CASE #: Z (CD)-01-18

DESCRIPTION: Zoning Map Amendment
RM-1 (Residential Medium Density) to RV-CD (Residential Village)

Pitts School Road Rezoning Application Resubmittal 4-4-2018

Comments from Planning and Zoning Board Meeting

Pitts School Road Subdivision | Drainage Overlay Exhibit

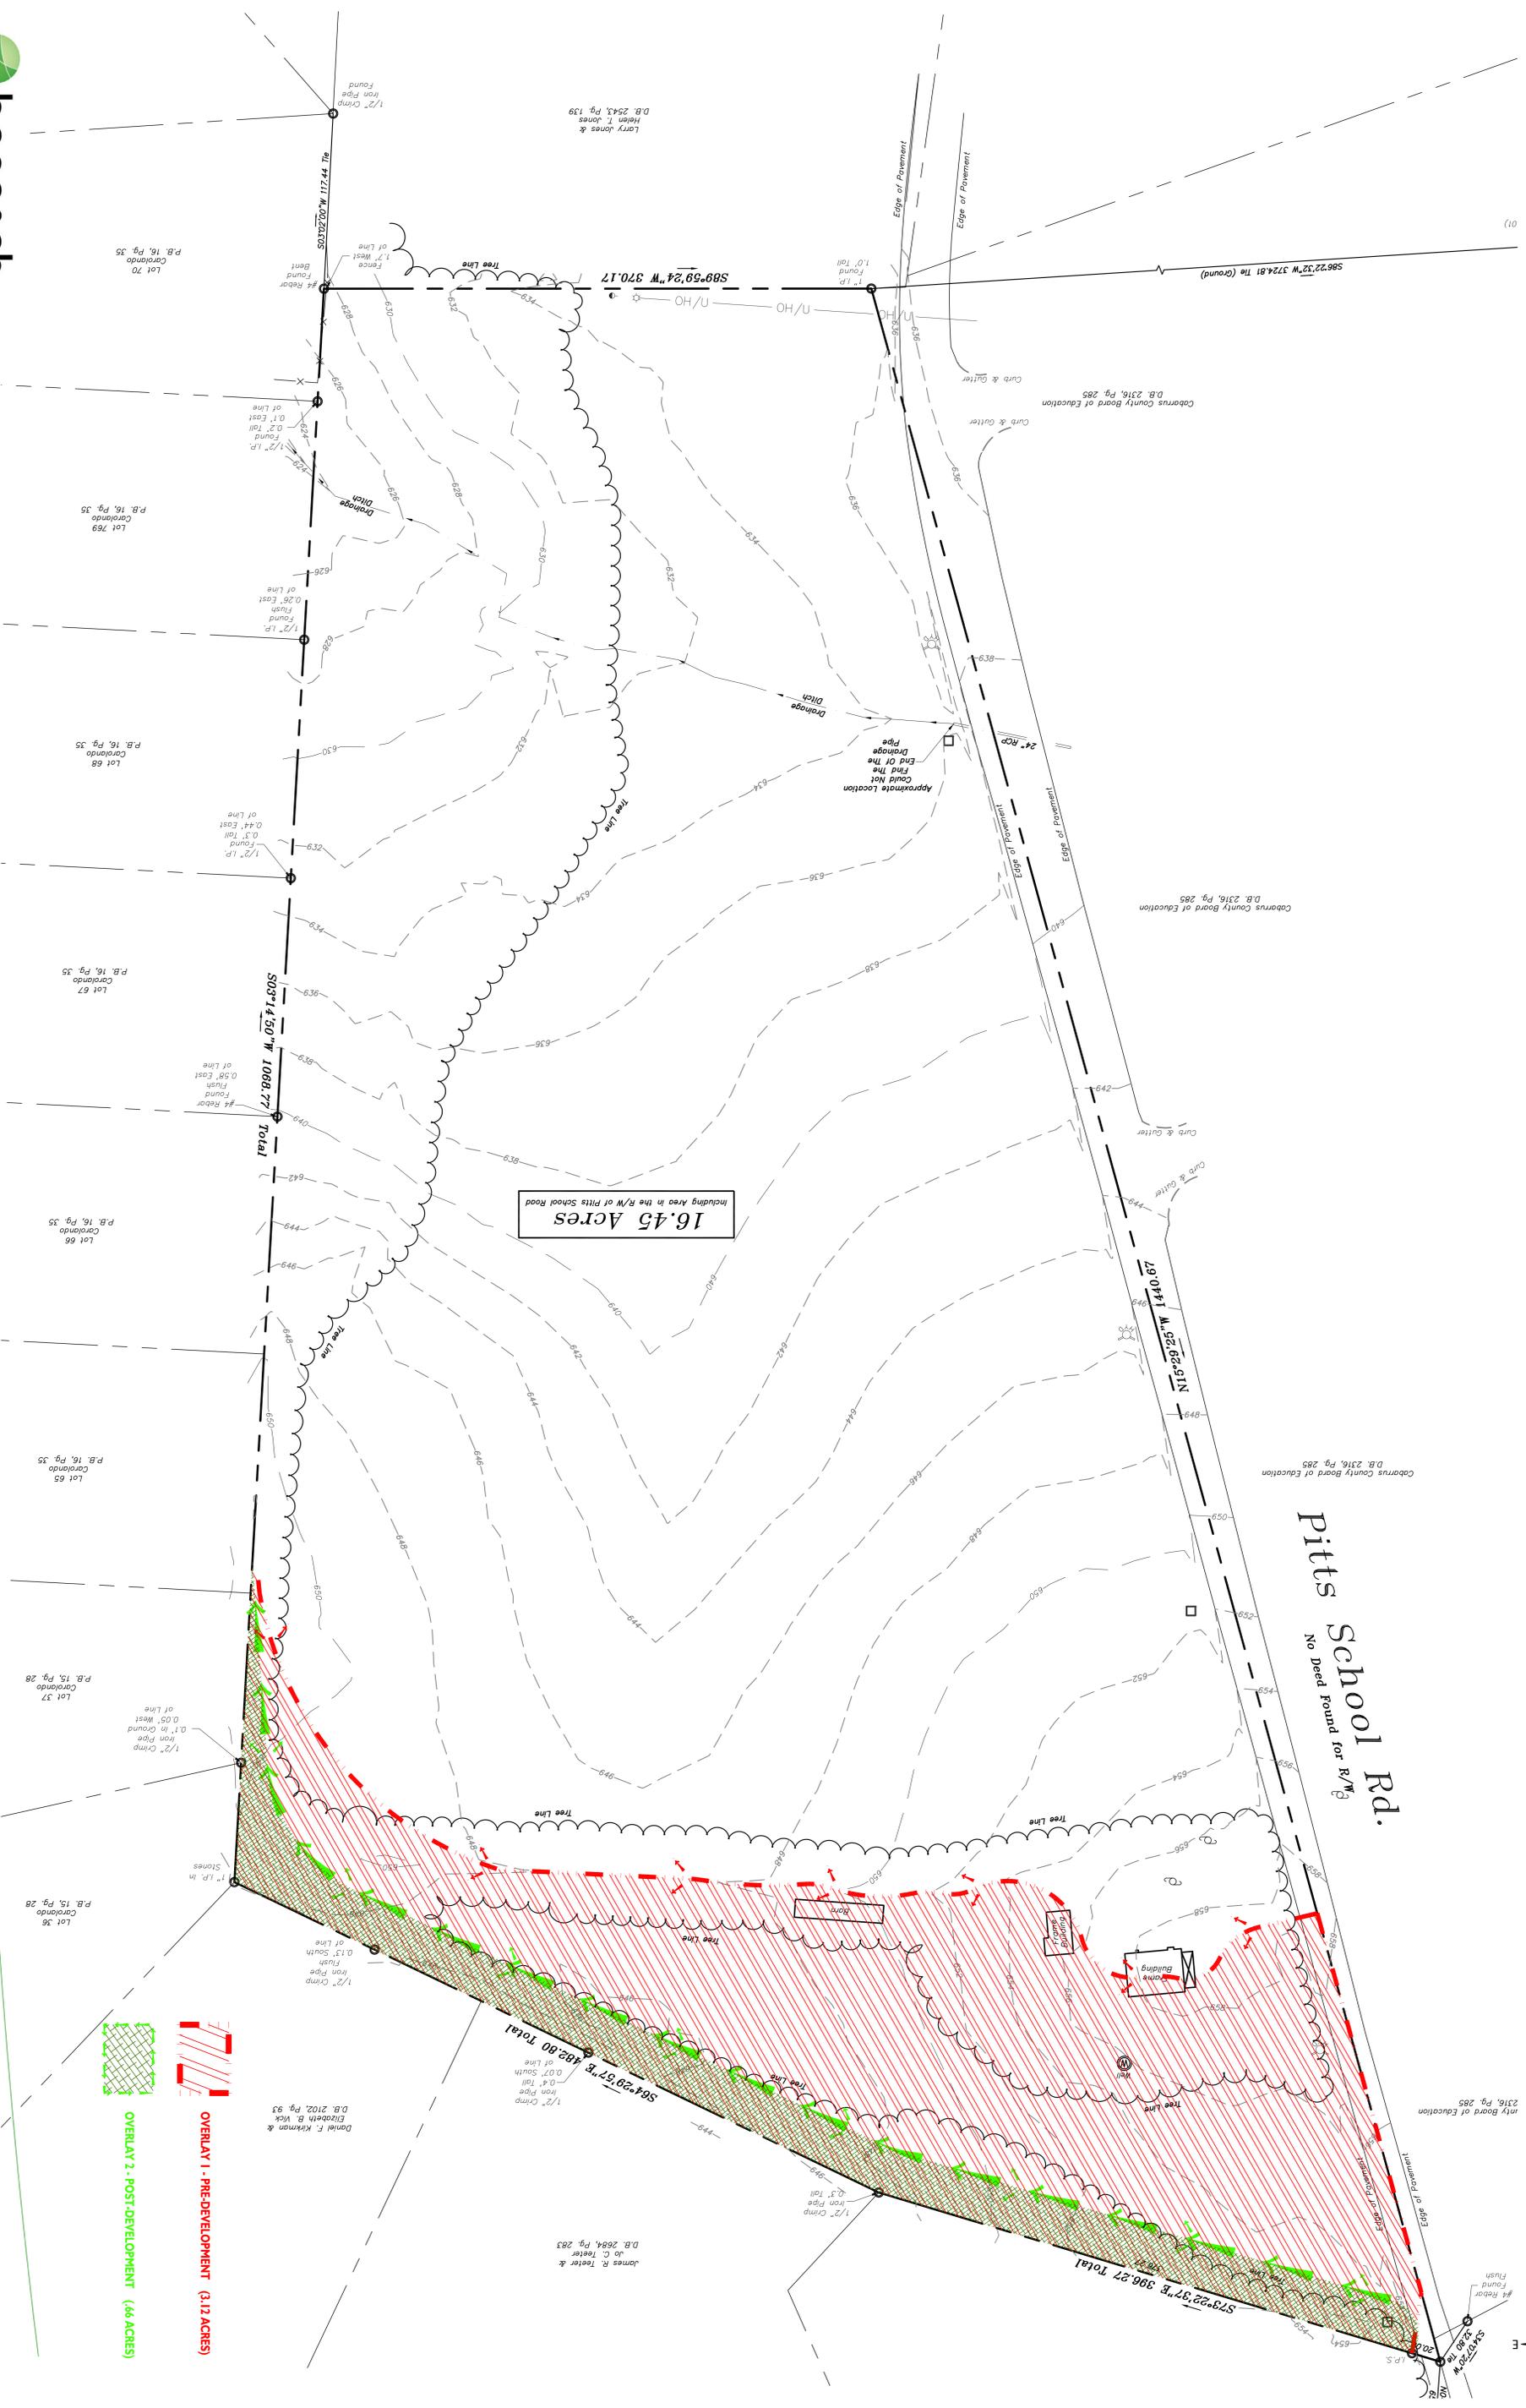
5. Drainage from the site is a problem for many of the adjoining neighbors. We would like a swale added to capture or divert the runoff.

We have secured a field run topo, analyzed the existing grades and reviewed the site in the field to confirm drainage patterns and issues. Currently, the undeveloped site discharges approximately 3.12 acres of land onto mostly the northern adjoining lots. That drainage is uncontrolled and at times runs off bare soil. In the developed condition, the swale requested would be incorporated and the majority of the developed discharge would be captured and treated for quality and quantity in an on site Stormwater Treatment Facility. The resulting discharge remaining beyond the swale is approximately 0.66 acres, mostly wooded, sheet flow. Most of the surface flow onto the Adjoining lots to the North will be eliminated.

- ▨ **OVERLAY 1 - PRE-DEVELOPMENT (3.12 ACRES)**
- ▨ **OVERLAY 2 - POST-DEVELOPMENT (.66 ACRES)**

Pitts School Road Subdivison | Conceptual Site Plan with Survey

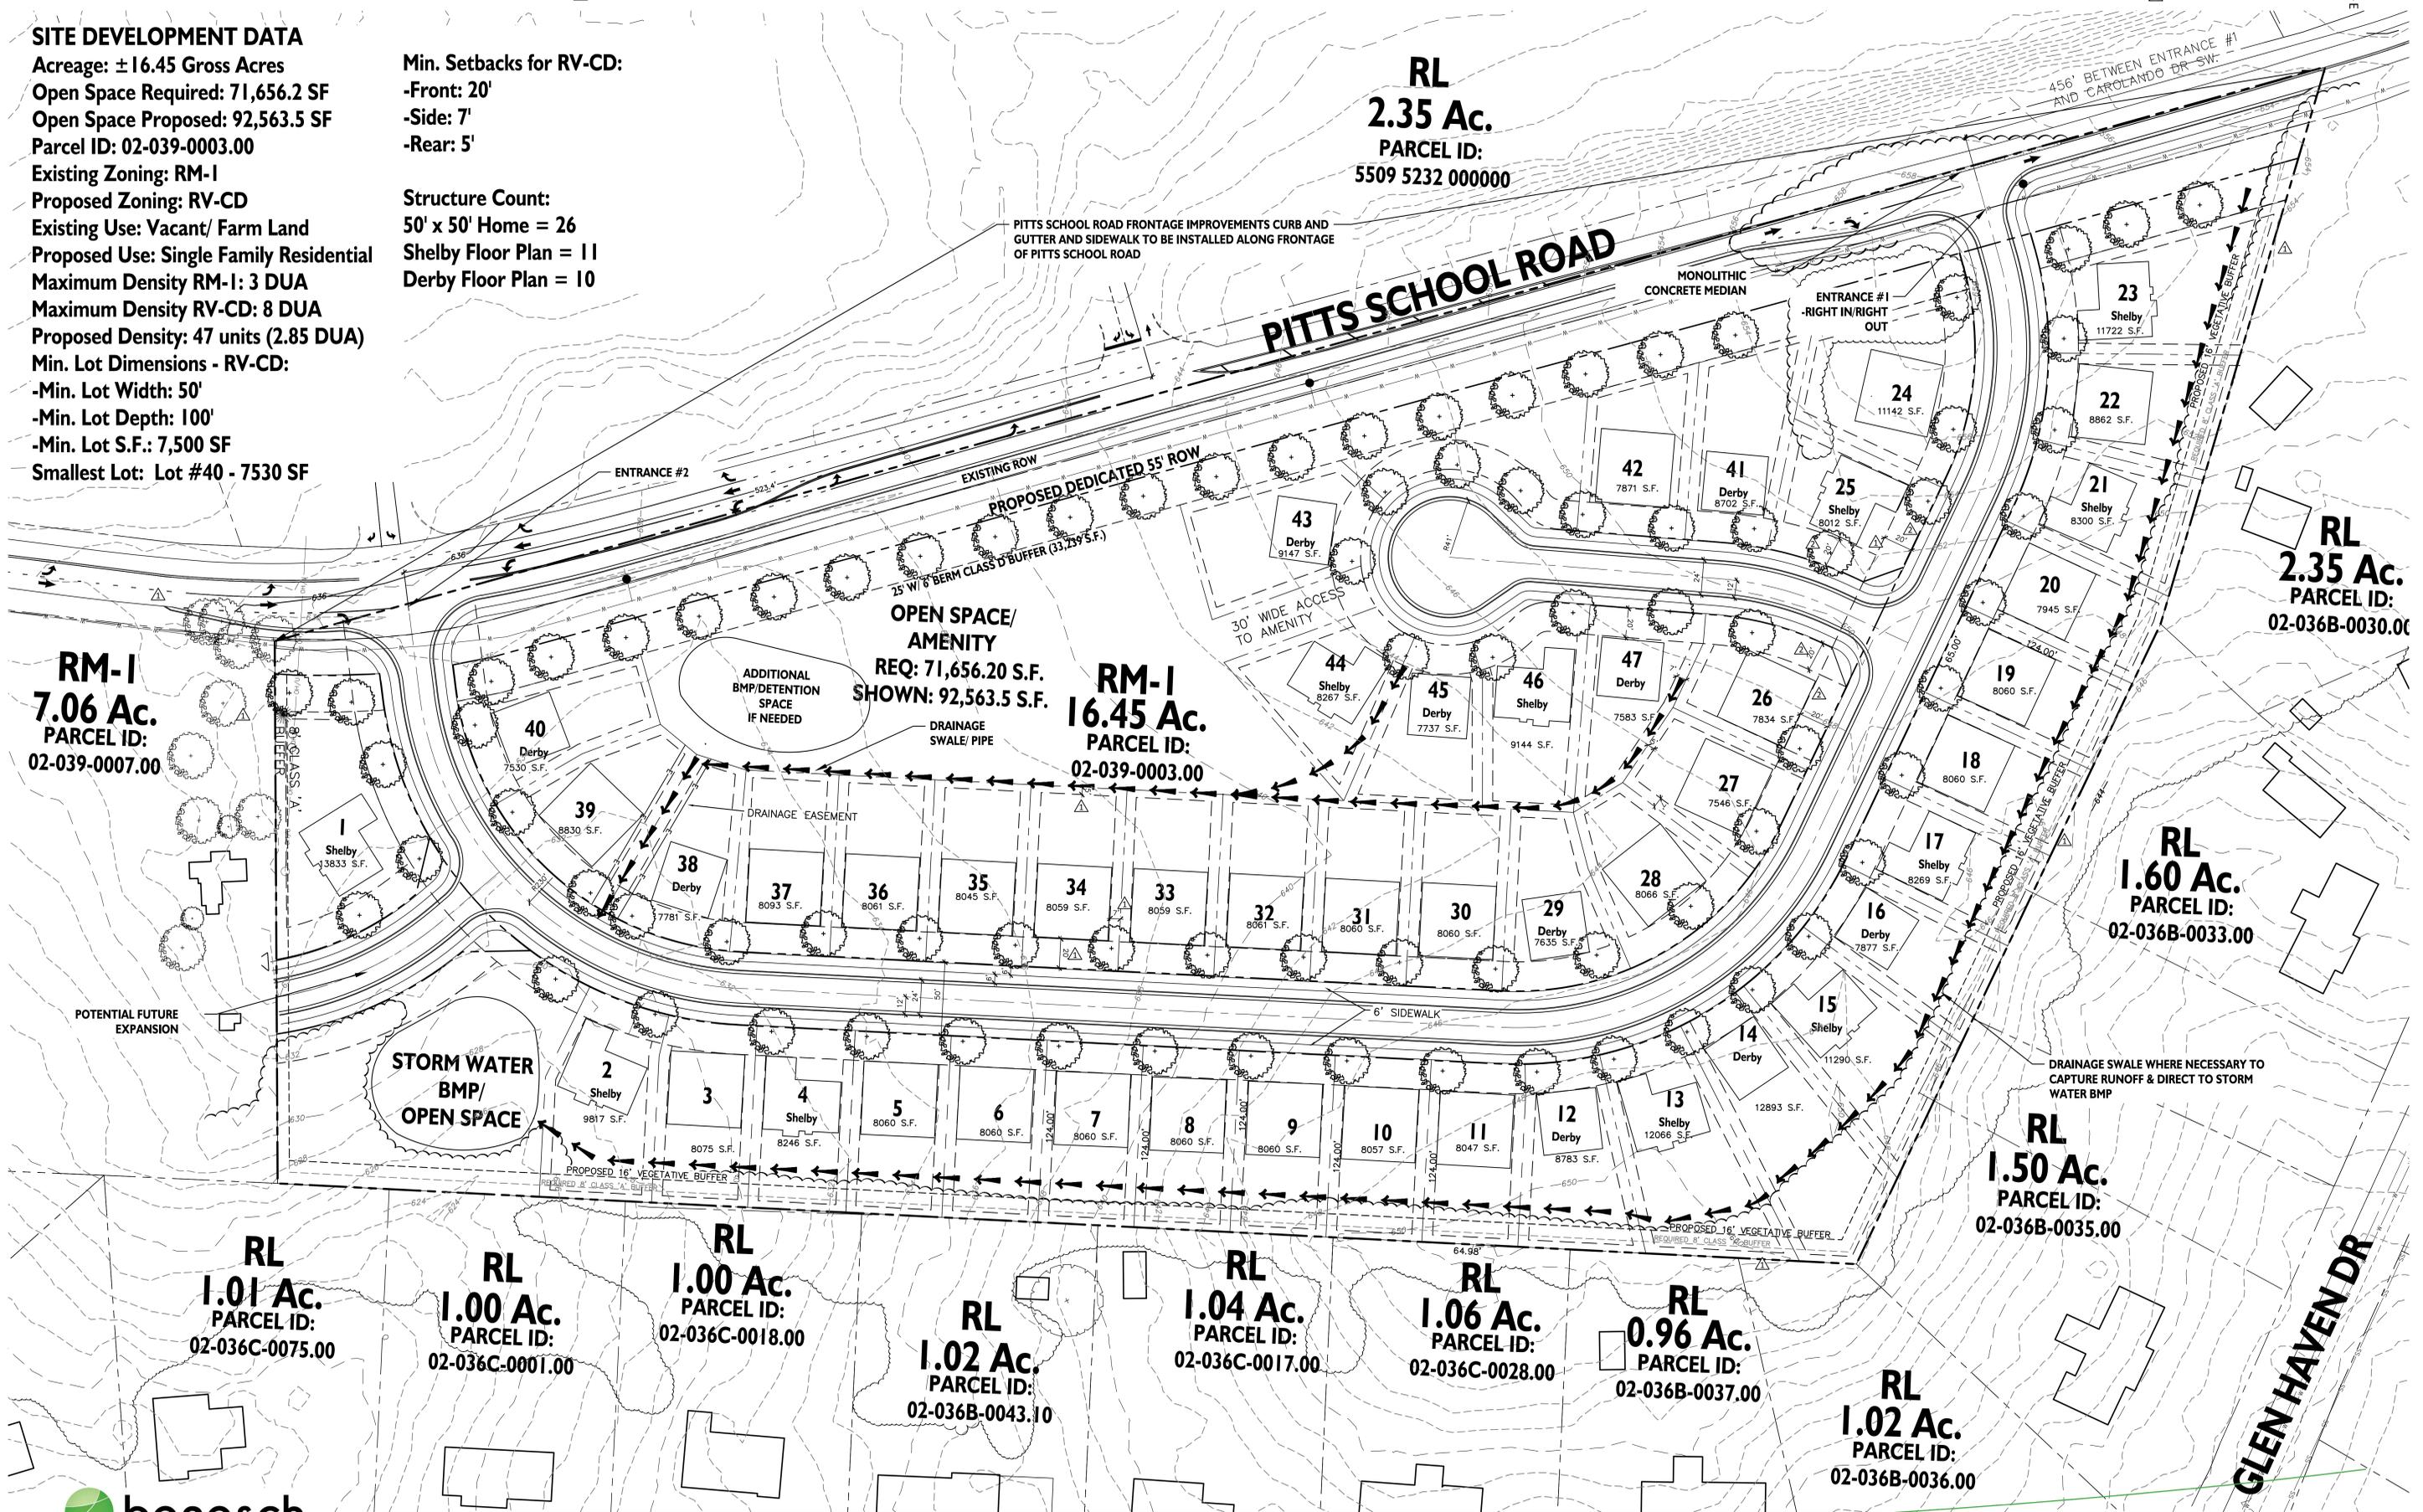
1. Request to reduce density and increase lot sizes, closer to that of the adjoining neighborhood.

2. Reverse layout, moving open space adjacent to neighborhood.

3. Add a row of evergreen shrubs along the border.

4. Traffic on Pitts School Road is a concern.

Adjoining neighborhood was developed long ago with 1+ acre lots. The current cost of land and infrastructure precludes that scale of development in most conditions. Overall density for this development was planned at 49 homes or 2.98 DUA. Density on final plan has been reduced to 47 homes or 2.85 DUA. (current zoning allows for 3 DUA)

A study was done to review this option. Given the size of the open space, it would only benefit 2-3 lots in the adjoining neighborhood and expose 13 rear yards of lots directly to Pitts School Road. That would also result in a loss of 4 lots and make at least the 13 lots very difficult to market. It is not good planning or design.

The east and north borders are wooded which would require some level of clearing of that border in order to plant the shrubs and ensure survival. We considered a better solution would be to increase the required buffer to 16', doubling the buffer. To the extent that trees exist, they would be retained. Another benefit realized is the additional 8' is added to the lot depth, moving the homes farther away from the Adjoining neighbors and increasing those lot sizes.

Pitts School Road is a busy street. We spoke with the NCDOT District office in Albemarle. We discussed the driveway connections with Leah Wagner and confirmed their requirements. We will be adding a left turn and right turn lane into the southern driveway. The location across from the School driveway is acceptable. We will add a concrete median in Pitts School Road at the northern driveway, creating a right in, right out only entrance. We will also widen sufficient for the median and add a right turn lane into the site at that entrance as well.

PITTS SCHOOL ROAD FRONTAGE IMPROVEMENTS CURB AND GUTTER AND SIDEWALK TO BE INSTALLED ALONG FRONTAGE OF PITTS SCHOOL ROAD

DRAINAGE SWALE WHERE NECESSARY TO CAPTURE RUNOFF & DIRECT TO STORM WATER BMP
